CITY OF MANZANITA Manzanita Classic Street Connection Project Addendum Number 2

DATE: May 7, 2025

ENGINEERING PLANS - ADDENDUM 2

SIGNAGE AND STRIPING PLAN

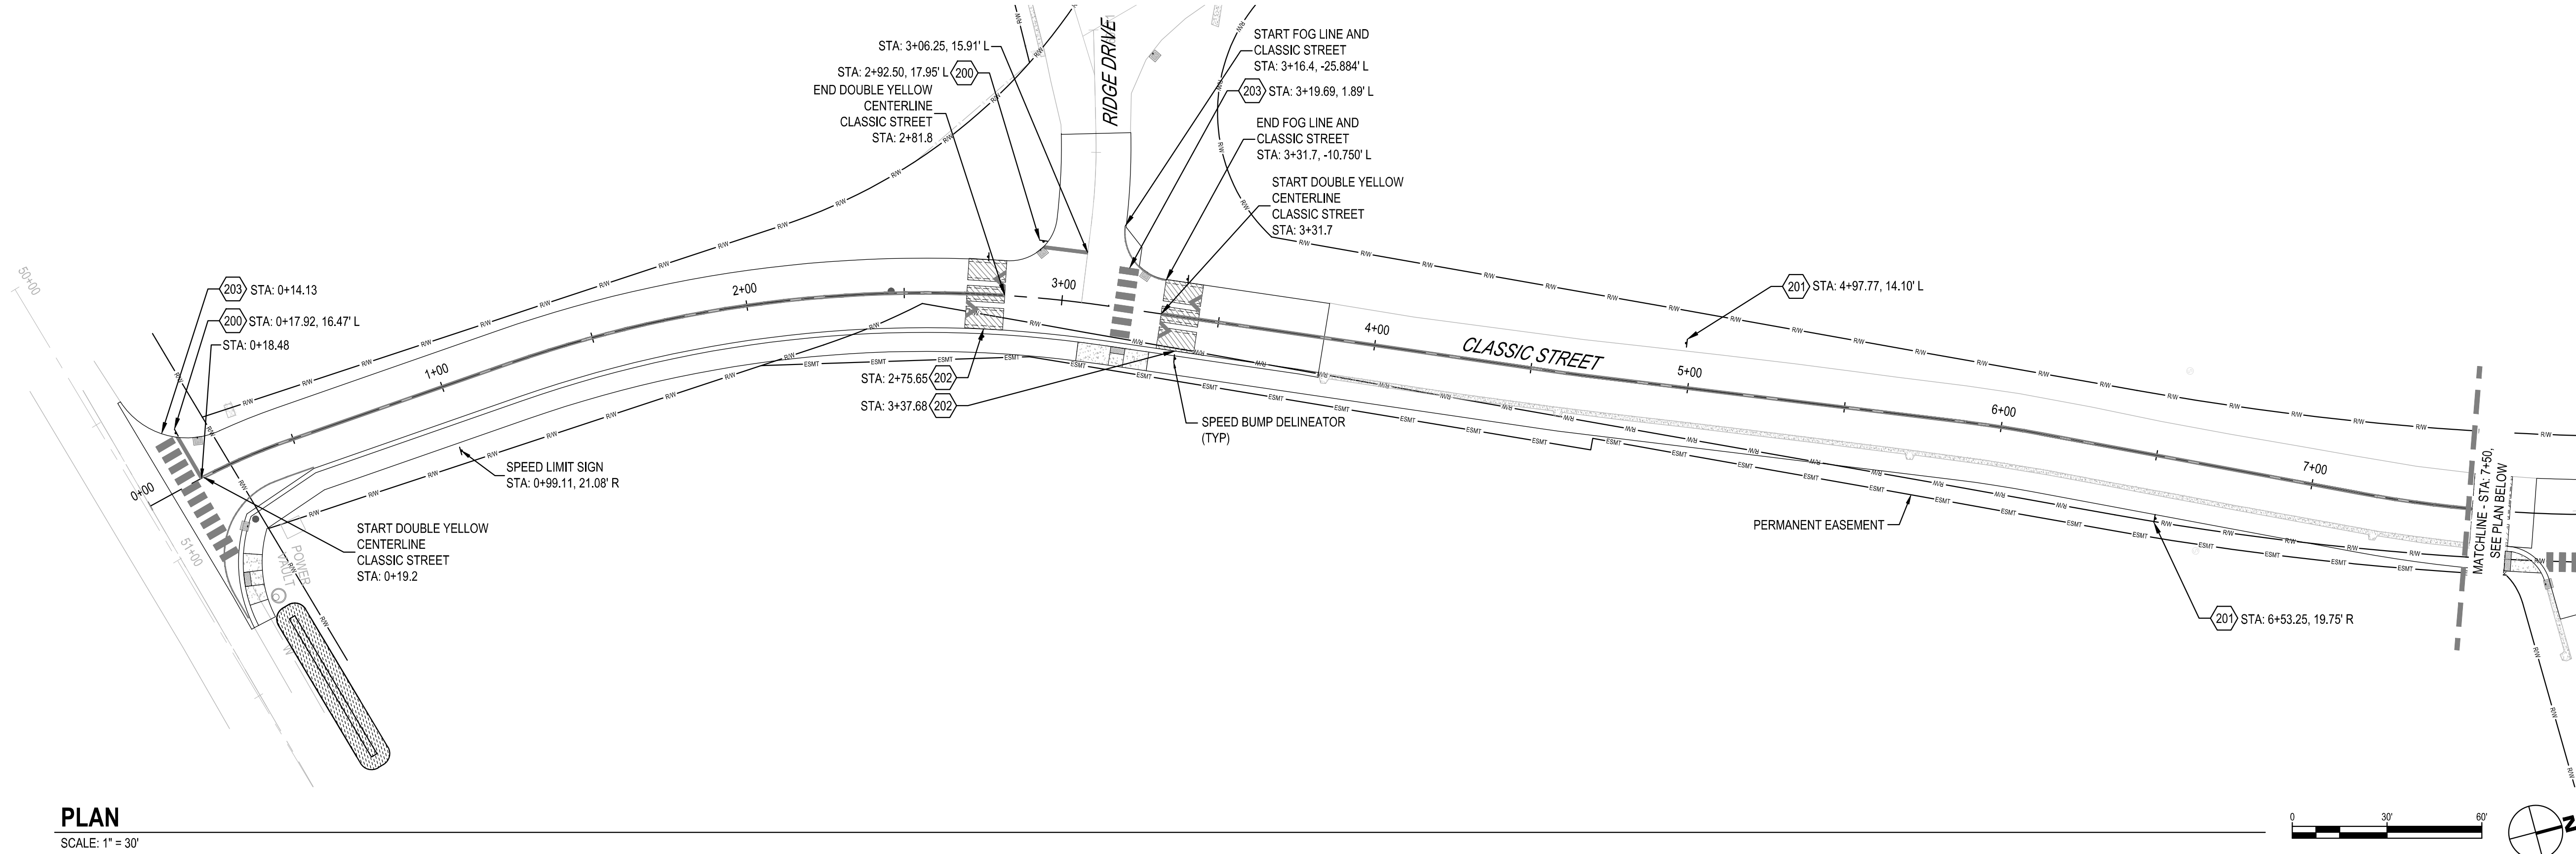
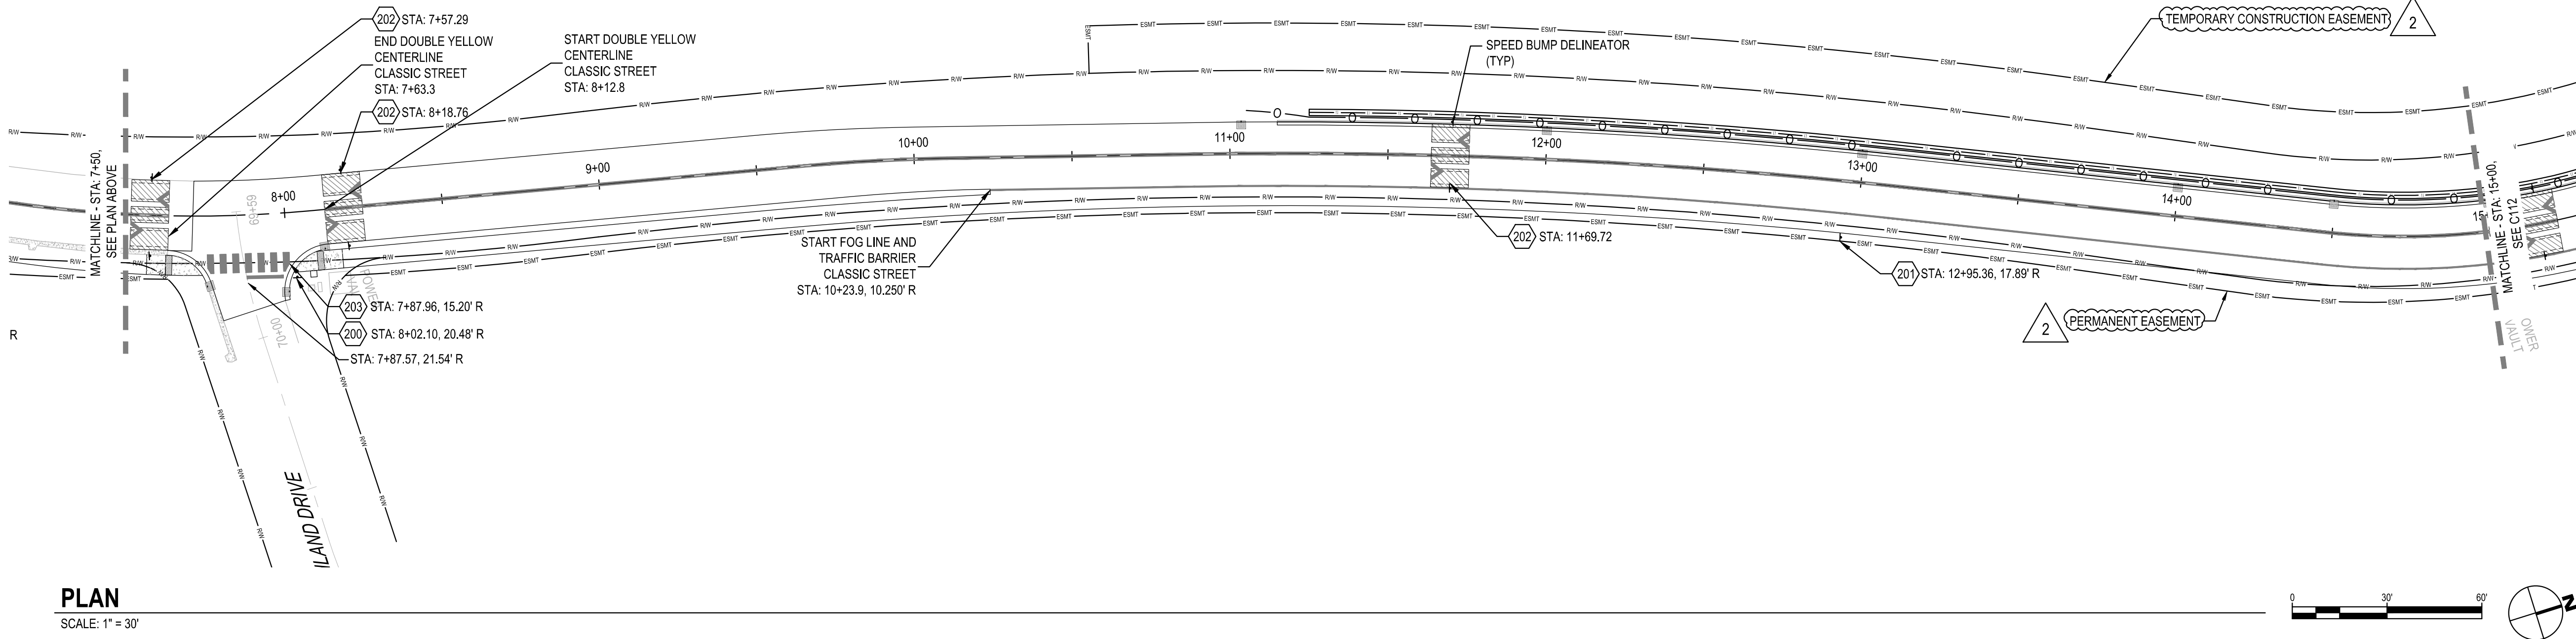
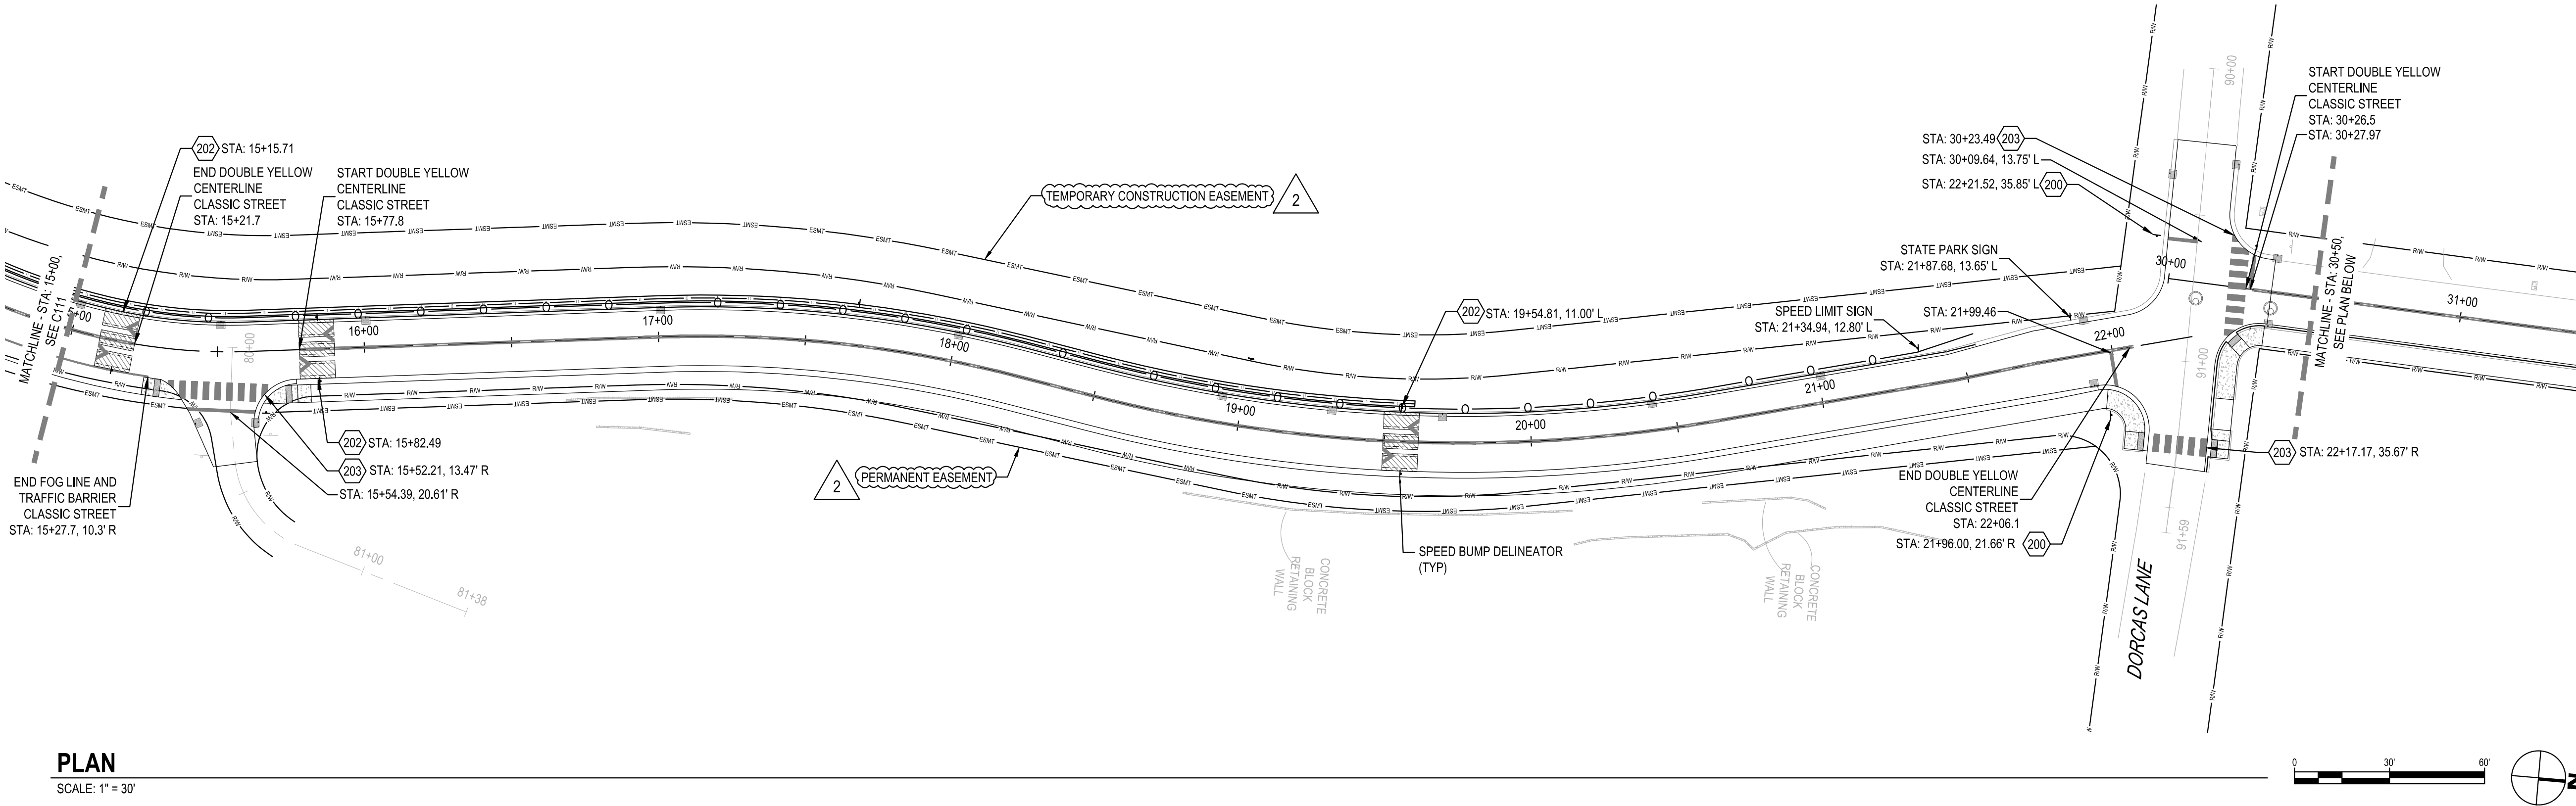
- **C270, C271** – Signage and Striping: Call outs for “Temporary Construction Easement” and “Permanent Easement.”
 - **C502** – Details: Detail 4 Chain Link Fence Updated to refer to gravity block retaining wall connection.
